UNITED STATES PATENT AND TRADEMARK OFFICE

APPLICATION NO.	FILING DATE	FIRST NAMED INVENTOR	ATTORNEY DOCKET NO.	CONFIRMATION NO.
09/824,490	04/02/2001	James W. Webster	560043620560	9378

Office Action Summary

FIG 6

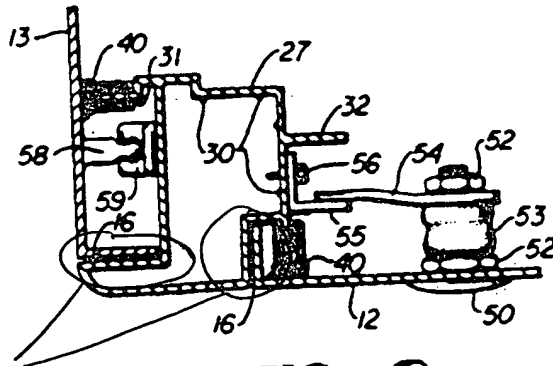
location of
2nd seal
